Southern Nuclear Operating Company
Vogtle Electric Generating Plant Units 3 and 4
Early Site Permit Site Safety Analysis Report Amendment Request
Response to Request for Additional Information

Enclosure: Response to NRC Request for Additional Information on the License
Amendment Request to Change the VEGP Units 3 and 4 ESP SSAR
Regarding Onsite Backfill Areas

**Response to NRC Request for Additional Information
on the License Amendment Request to
Change the VEGP Units 3 and 4 ESP SSAR
Regarding Onsite Backfill Areas**

Figure 1. Map Showing Extent of Barnwell Group

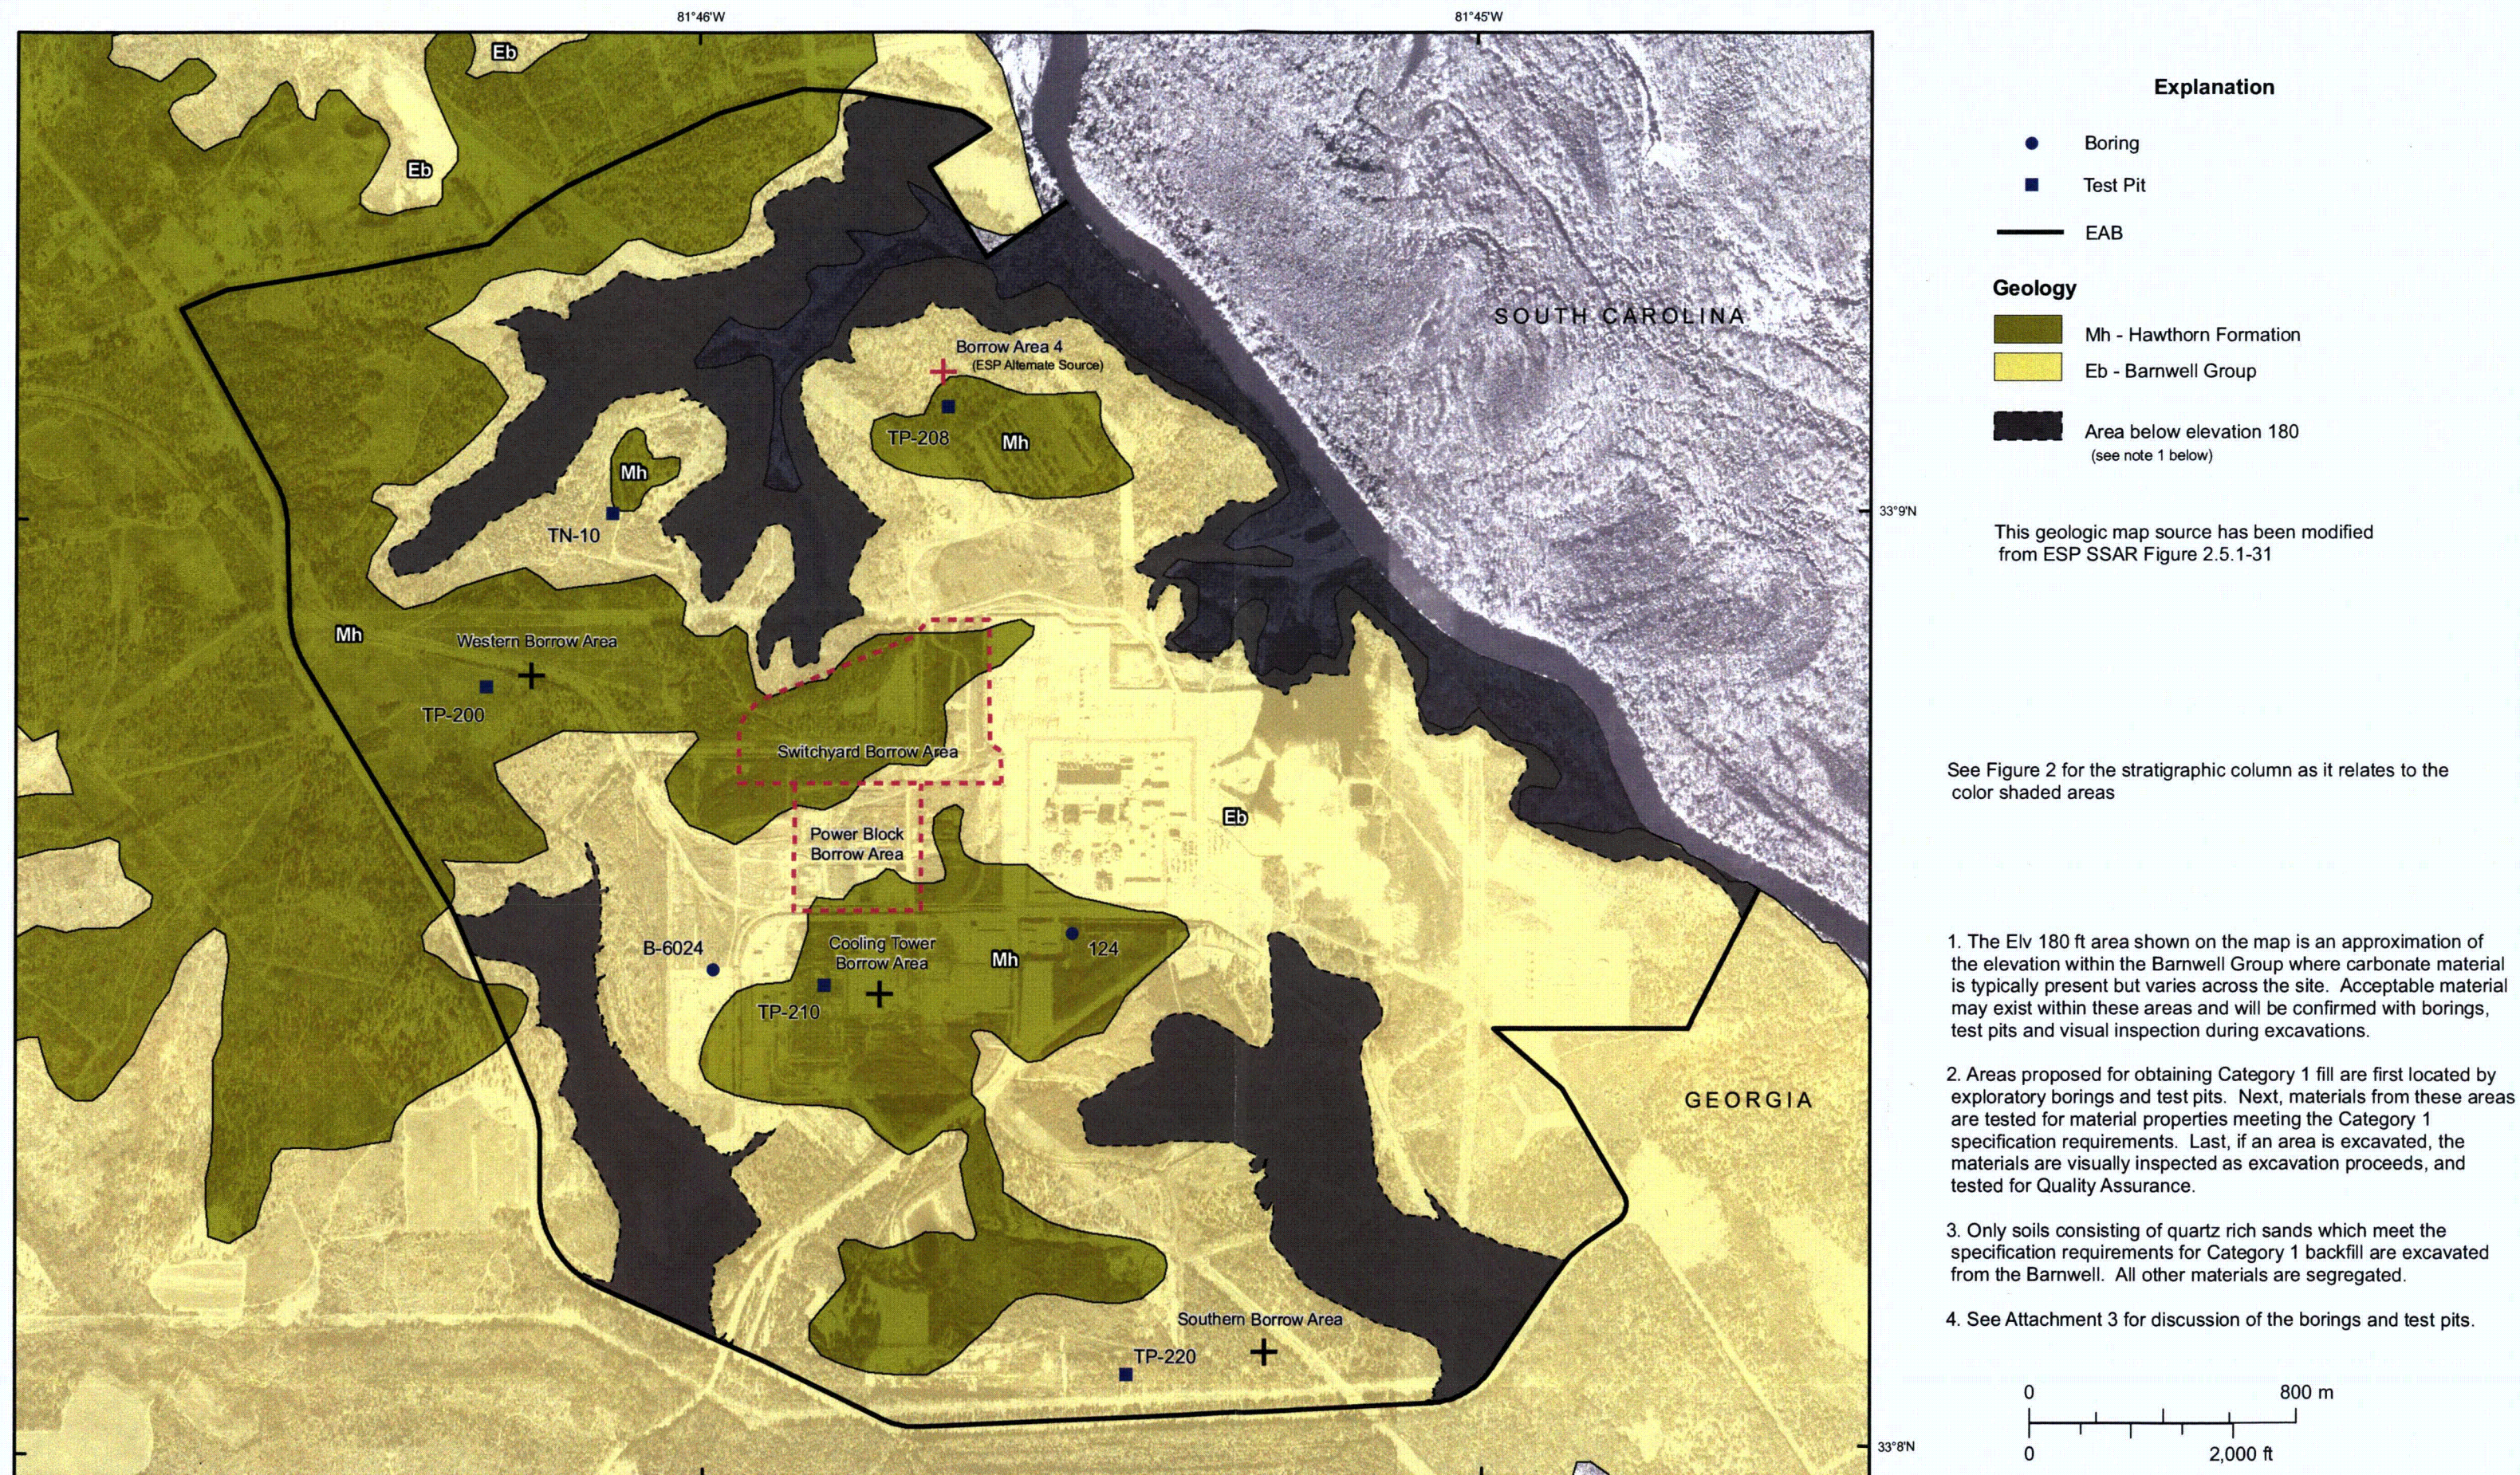
The basis the applicant uses to conclude that backfill obtained from additional onsite borrow areas located inside the boundaries of the VEGP site is from the same geological origin as the existing ESP approved areas is not clear. Provide the basis for concluding that backfill obtained from additional onsite borrow areas and located inside the boundaries of the VEGP site, will be from the same geological origin as the existing ESP approved areas.

The aerial extent of the Barnwell Group sediments respective to the VEGP Site and surrounding area are shown on Figure 1. These geologic contacts were derived from the ESP SSAR Figure 2.5.1-31. Also shown are the locations of the 3 active borrow areas mentioned above and locations of additional borrow areas not currently described in ESP SSAR section 2.5.4.5.4. Representative borings and test pits in various areas across the VEGP Site are also shown. The material descriptions from these logs are typical of the upper sands within the Barnwell Group and are consistent with larger scale exposures of the Barnwell in the Unit 3 and 4 excavation, surrounding road cuts, and other areas of excavation such as the abandoned borrow area in the southern portion of the site used for Units 1 and 2. These observations confirm the presence of the Barnwell Group throughout the VEGP Site.

Upper Sands of the Barnwell Group are shown on Figure 1 respective to borrow areas for the Unit 3 and 4 Power Block Area and Switchyard, Borrow Area 4 (ESP approved areas), and proposed expansion of borrow areas within the VEGP owner controlled area (EAB).

Observations from the Units 1 & 2 and 3 & 4 excavations as well as geologic maps and investigations indicate that below about elevation 180 feet material contains variable amounts of carbonate that are unacceptable for use as backfill. Areas below elevation 180 feet are shown on Figure 1. New proposed borrow area locations are confirmed with borings and test pits. Actual excavation of borrow materials requires visual inspection and testing to confirm engineering properties as specified for all Category I backfill material prior to use.
